CERTIFICATE OF APPROPRIATENESS PLACARD

515 N BLOUNT STREET

LEWIS-SMITH HOUSE

PERMIT REVIEW COMMENTS / HISTORIC DISTRICT (TANIA TULLY 3/25/2014):

A099

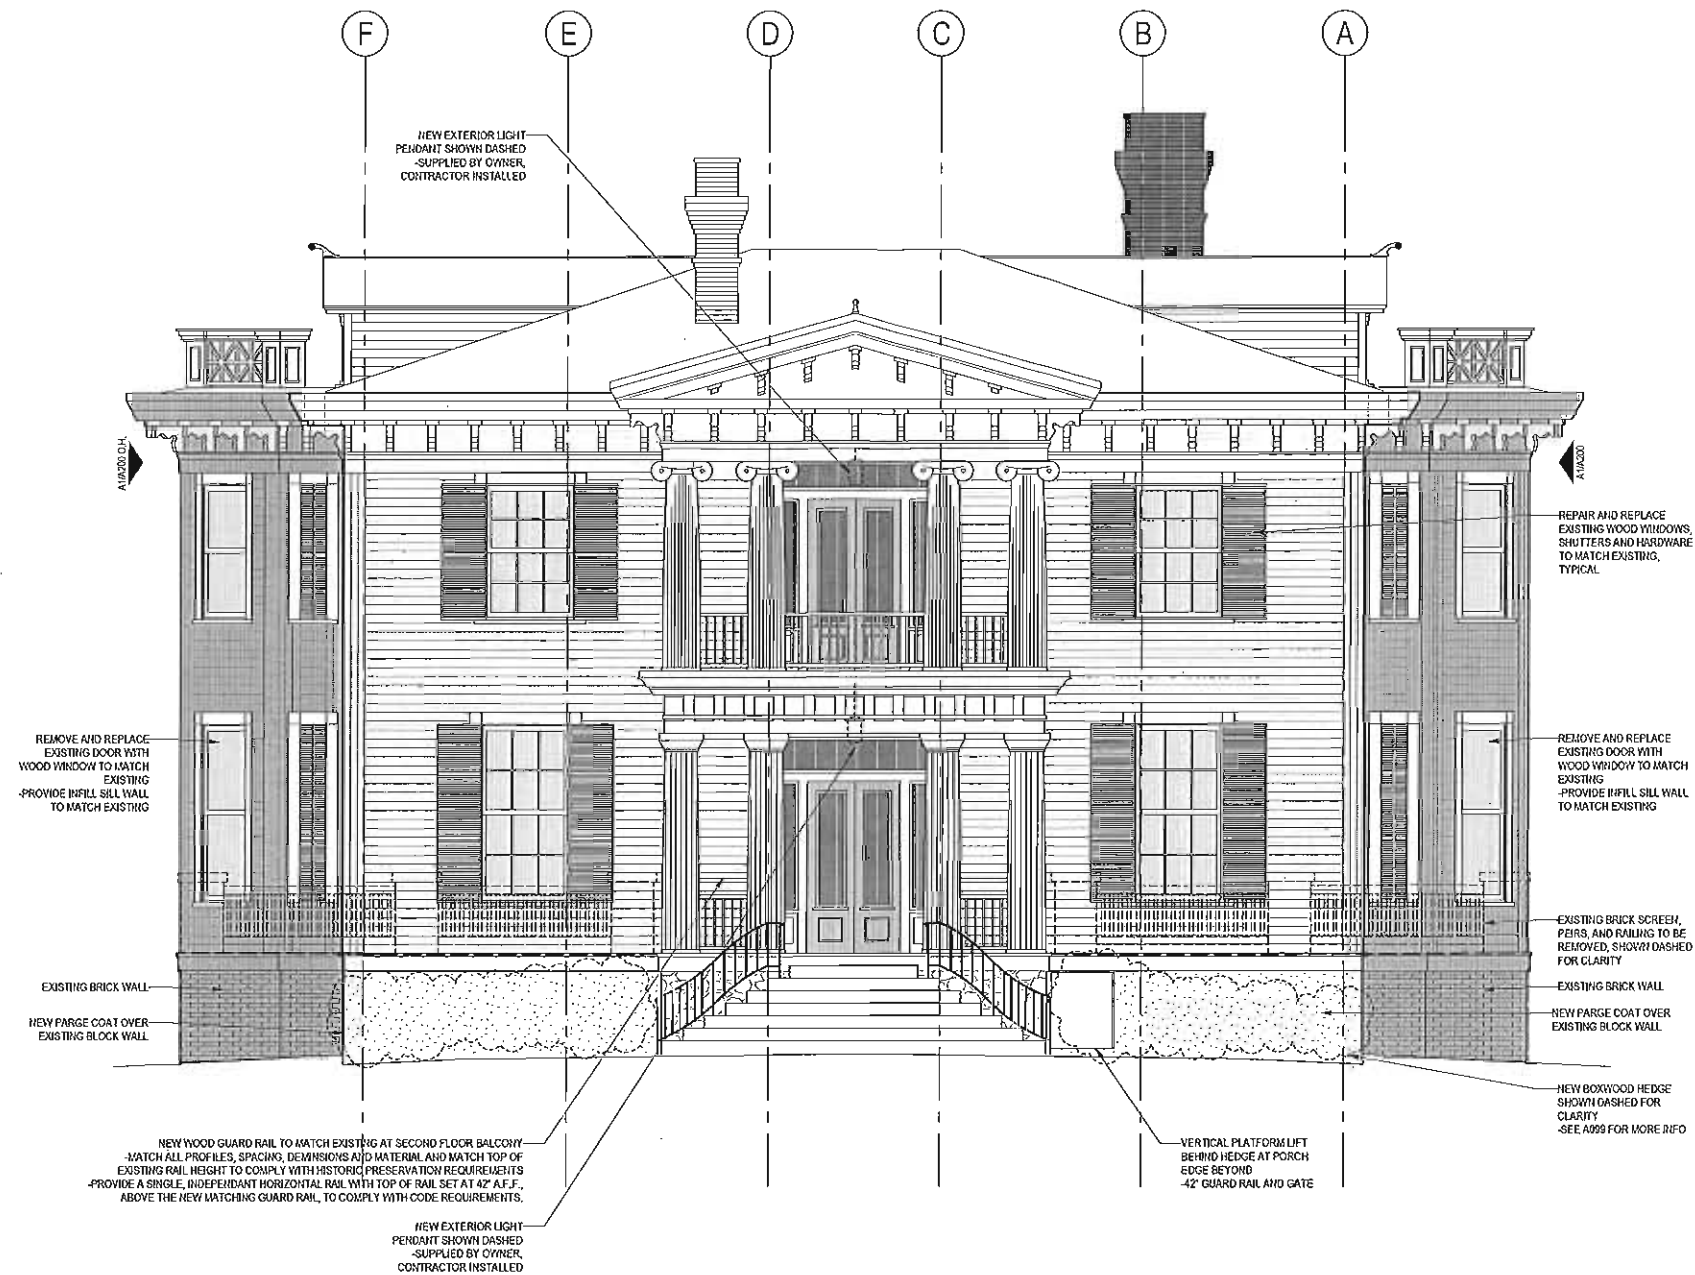
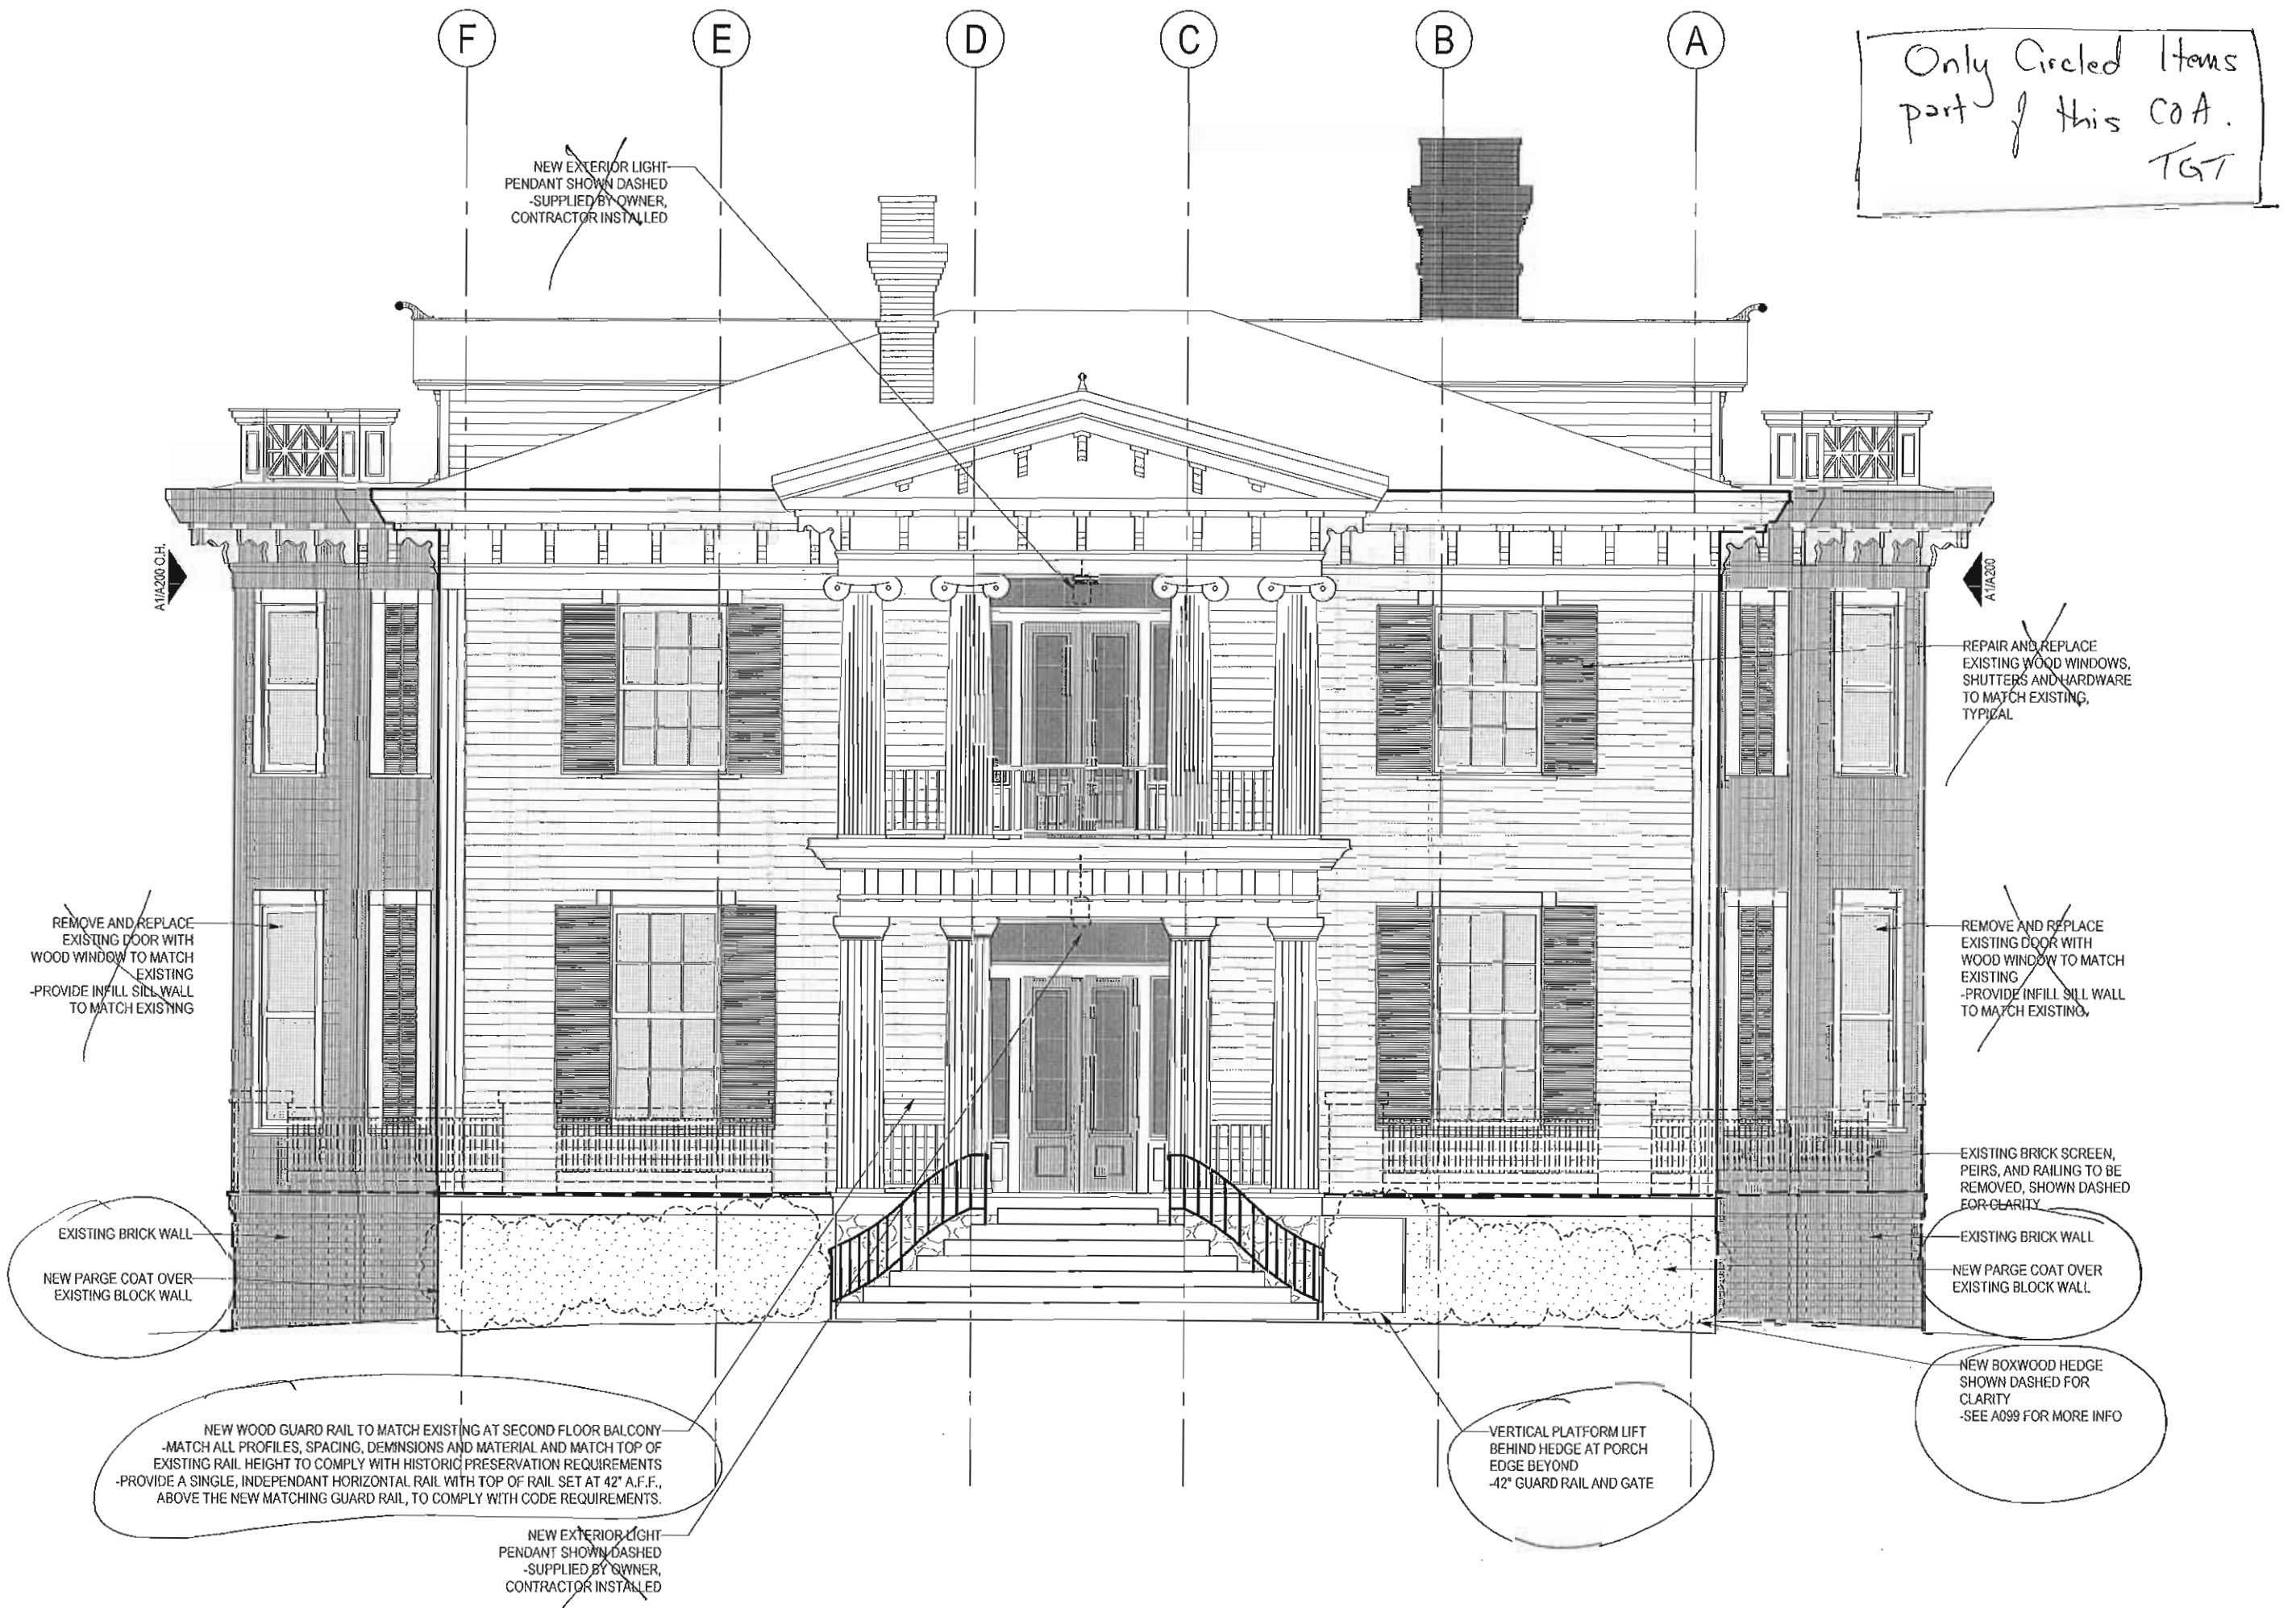
- NOT THIS COA
- Master landscape plan (condition 3) — Needs a COA — May or may not be Minor.
- RESPONSE : Landscape shown on sheet A099 is for quantity and code calculations only. A final landscape plan will be submitted for staff review prior to procurement or installation of landscape elements.

new concrete walkway

gravel (approved per CoA 039-12-MW)

Only Circled Item
part of this CoA.
1GT

SHEET NO.
A200

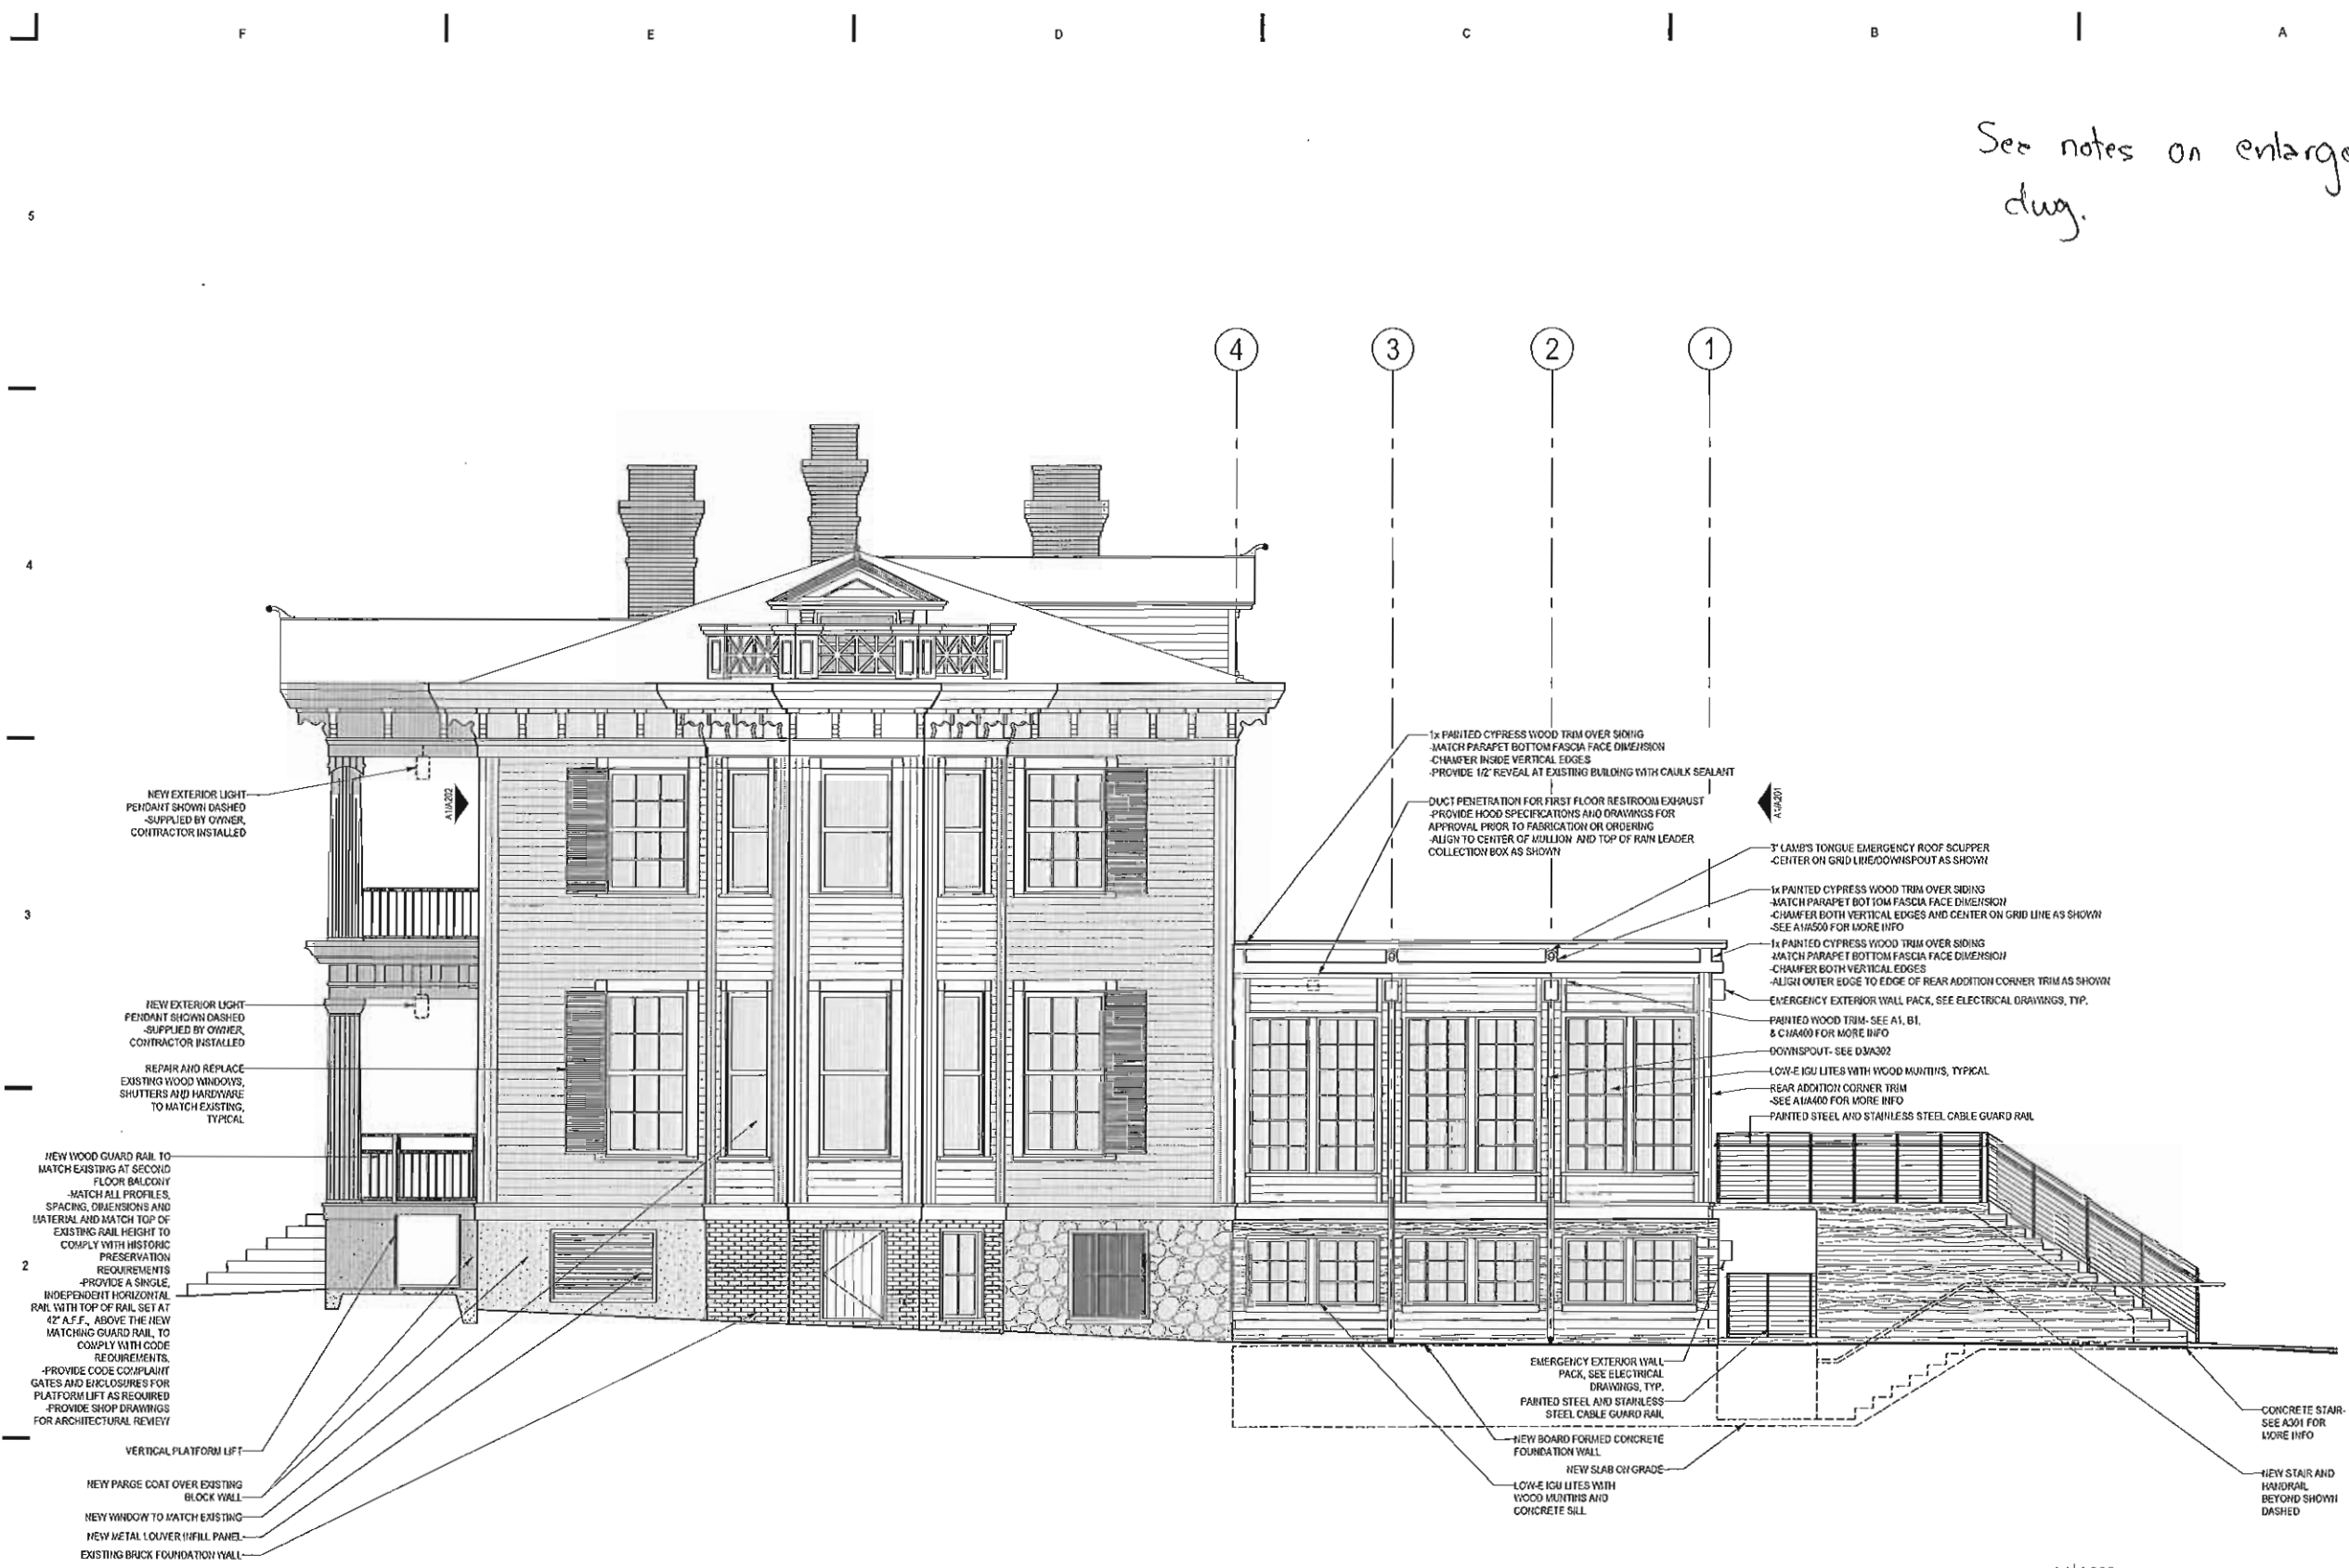
- NOT THIS COA
- Drawings still note that windows and shutters will be repaired or replaced. Replacement has not been approved. (conditions 1 & 2)
- RESPONSE : Notes utilizing the word "replace" do so in reference to missing windows and shutters or those components damaged beyond repair. A schedule of repair or replacement will be submitted for staff review prior to any demolition or repair work. Clarification has been added to elevations on sheets A200, A201, and A202.

- New railing on front porch (should match height of 2nd level railing)
- RESPONSE : A new railing on the front porch at the 1st level will be installed to match the existing guard rail at the 2nd level balcony in height, profiles, and materials. A single higher rail at 42" above the finish floor level will also be provided to meet code requirements. The high rail will match materials and profiles of the historic top rail of the 2nd level balcony. See sheet A200 & A202.

NEW PARGE COAT OVER EXISTING
BLOCK WALL

EXISTING BRICK FOUNDATION WALL
